DDS- Planning & Zoning: Plan Review Application

Please describe your application action(s) and provide as much detail as possible. Attach additional pages if necessary: **special permit for outdoor drinking patio**

HOG RIVER BREWERY RELOCATION
 1420 Park St.
 Hartford, CT 06106

From: Paul Ashworth
Sent: Wednesday, July 13, 2022 3:34 PM
To: Berschet, Paige; Natalie Sweeney
Cc: Hartford Planning Division
Subject: RE: 1420 Park St - Special Permit Application - P&Z-COMM-2022-0264

1 PROPOSED SITE PLAN & ZONING INFORMATION

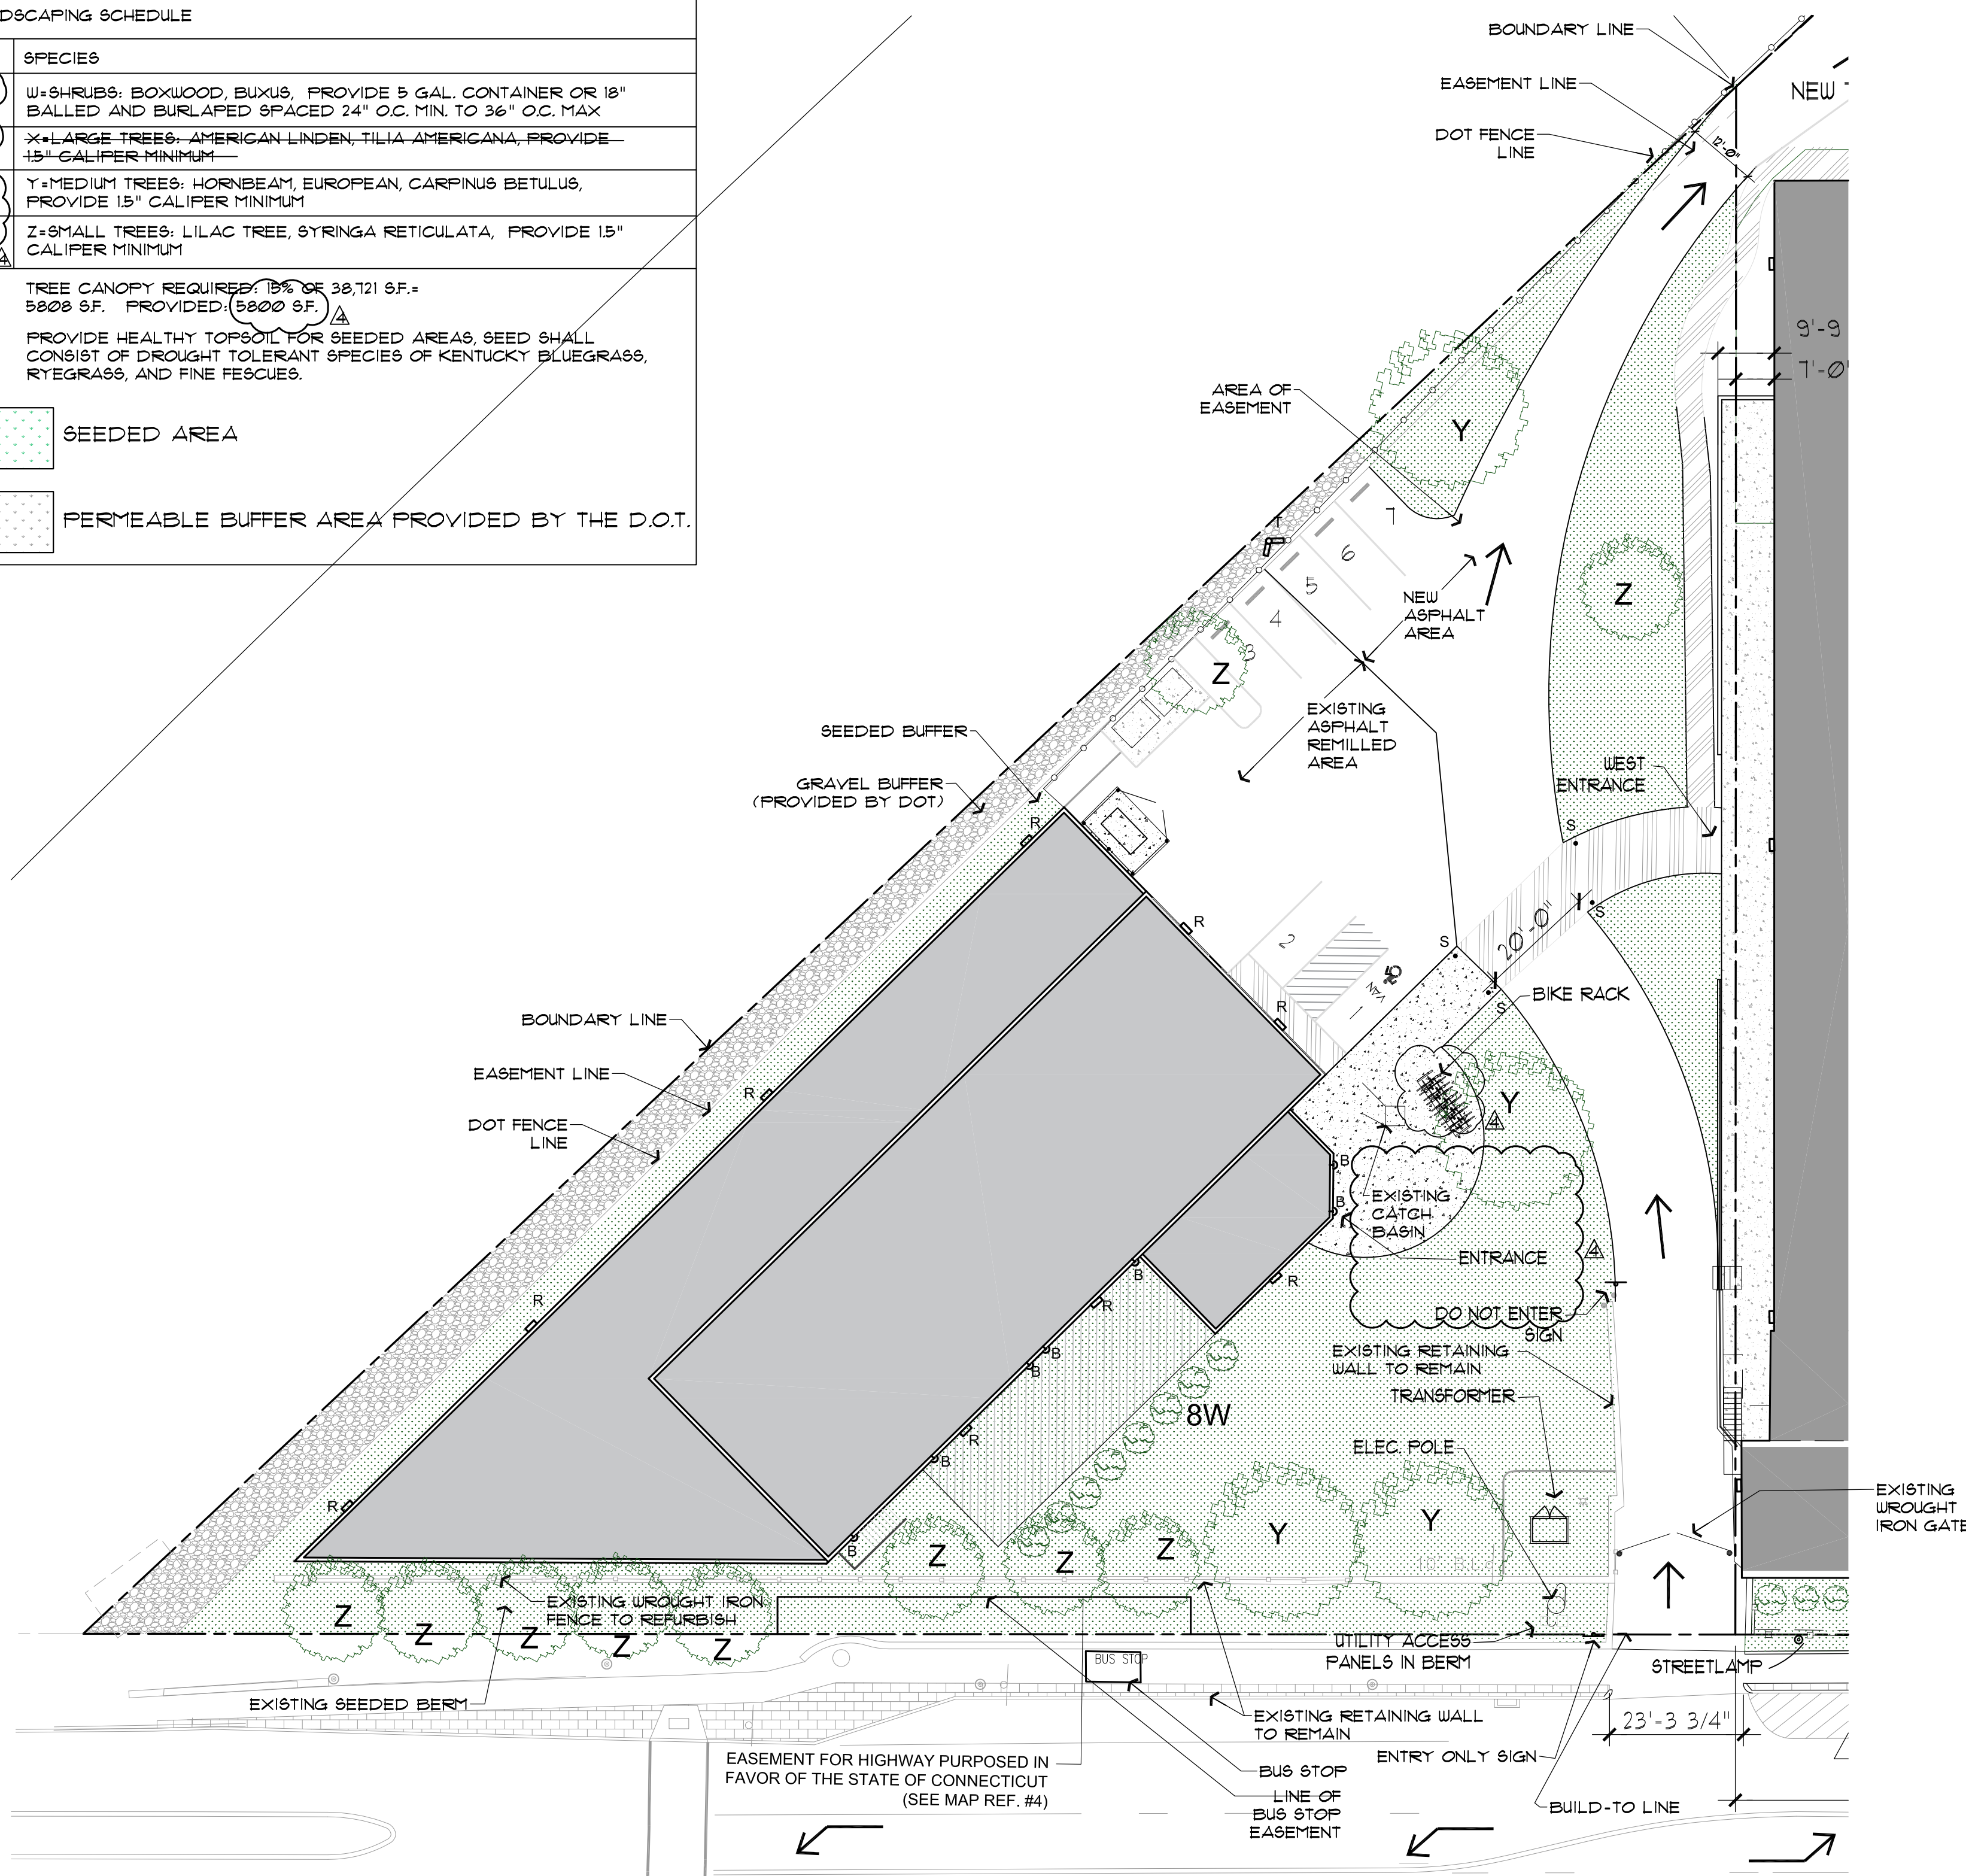
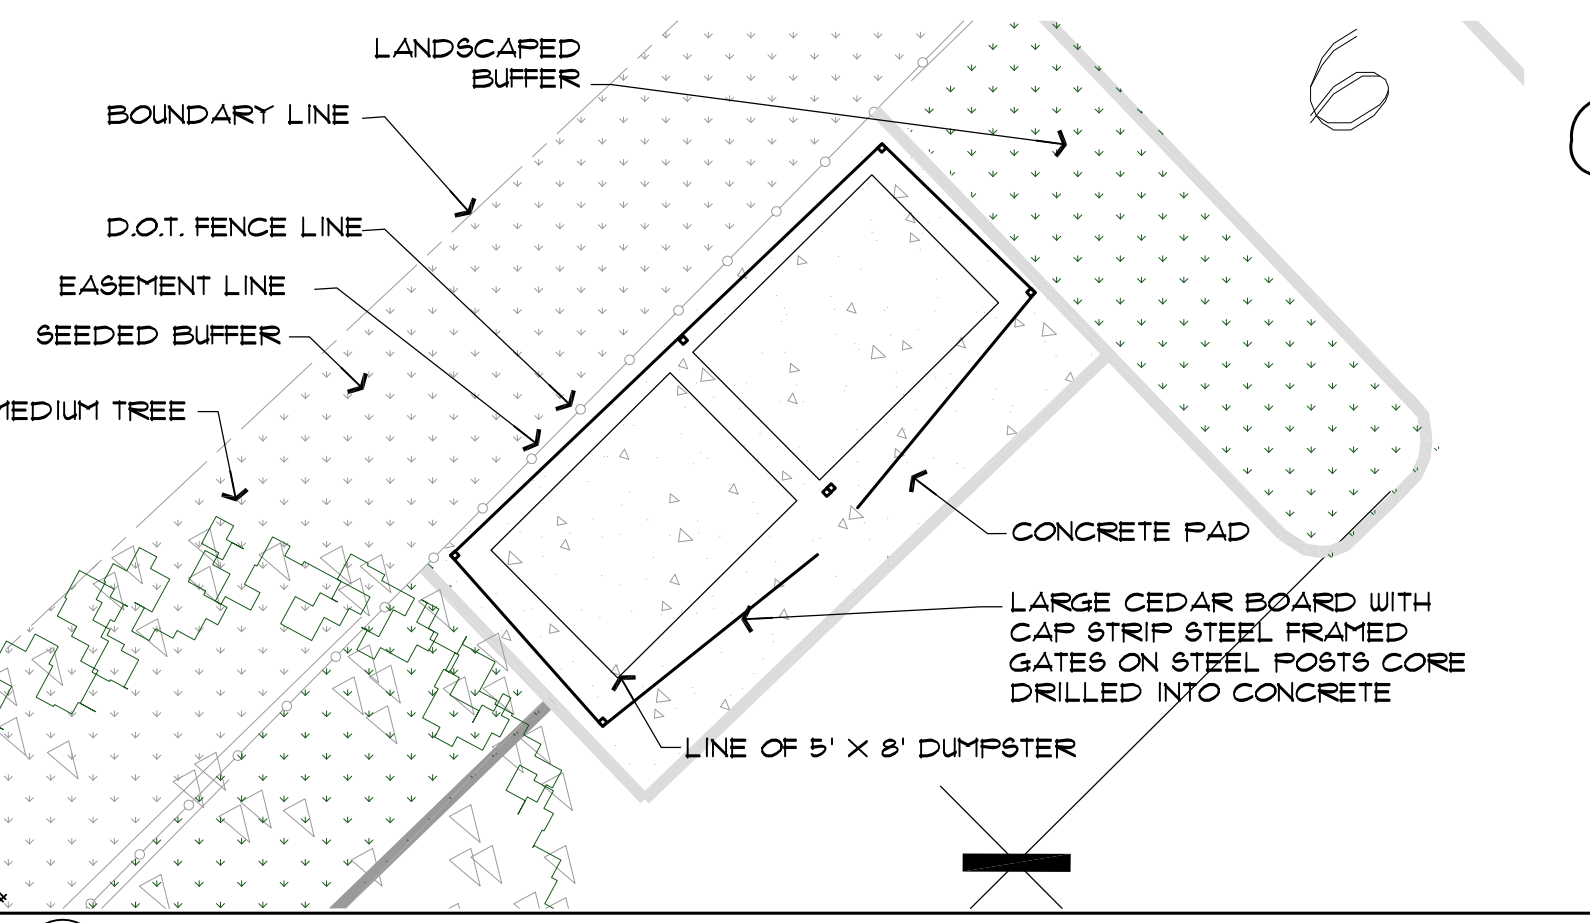
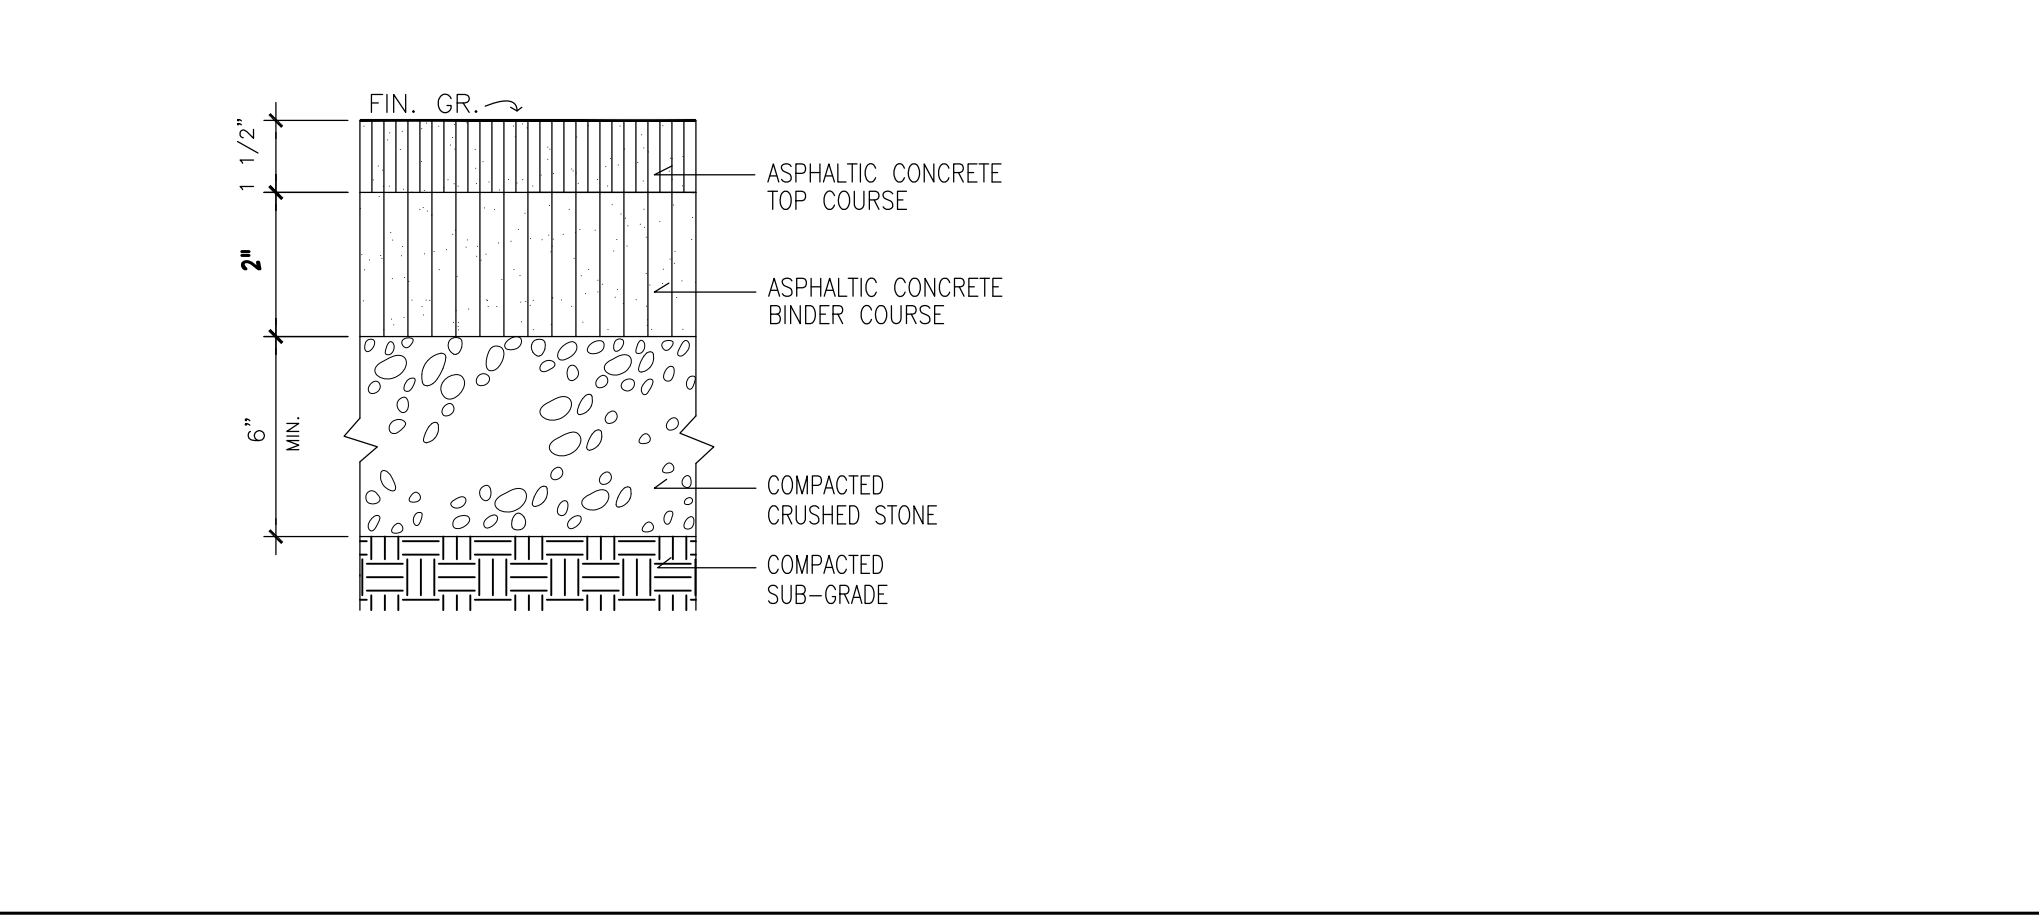
1. Please include a survey in the plan set. **Survey is included.**
2. Landscape plan was delivered to the City Forester's representative for review. **Lansdcaping Distribution has been revised.**
3. In zoning table on sheet SP-1. Multiple items are marked "Variance Accorded". I don't see a variance(s) on file. Please provide verification of a variance issued by the Zoning Board of Appeals for these items. Please note items #2 and #16 do not require variances. Item number 24 and 25 should be met. **Variances attached**

4. Section 4 on sheet SP-1 implies there is a minimum number of parking spaces and does not reflect City of Hartford parking requirements. Maximum parking for this use is 4 spaces per 1000 sf (see employment uses [i.e.craftsman industrial] in Fig.7.2-A). Revise table to show adherence with Hartford regulations. **Table revised on SP-1.**
5. Bicycle parking cannot be more than 50' from the entrance to a building and located on the same lot per Sec.7.3.3. Please show bicycle parking on site. **Shown on Sp-1.**
6. The ADA parking is currently shown in what could be the side or front yard. Parking is not permitted in this location. Please remove from the plan. **Parking was removed.**
Staff found no record of parking being approved in this location in the past.

1. Please include a survey in the plan set. **Survey is included.**
2. Landscape plan was delivered to the City Forester’s representative for review. **Lansdaping Distribution has been revised.**
3. In zoning table on sheet SP-1. Multiple items are marked “Variance Accorded”. I don’t see a variance(s) on file. Please provide verification of a variance issued by the Zoning Board of Appeals for these items. Please note items #2 and #16 do not require variances. Item number 24 and 25 should be met. **Variances attached**

4. Section 4 on sheet SP-1 implies there is a minimum number of parking spaces and does not reflect City of Hartford parking requirements. Maximum parking for this use is 4 spaces per 1000 sf (see employment uses [i.e.craftsman industrial] in Fig.7.2-A). Revise table to show adherence with Hartford regulations. **Table revised on SP-1.**
5. Bicycle parking cannot be more than 50’ from the entrance to a building and located on the same lot per Sec.7.3.3. Please show bicycle parking on site. **Shown on Sp-1.**
6. The ADA parking is currently shown in what could be the side or front yard. Parking is not permitted in this location. Please remove from the plan. **Parking was removed.** Staff found no record of parking being approved in this location in the past.
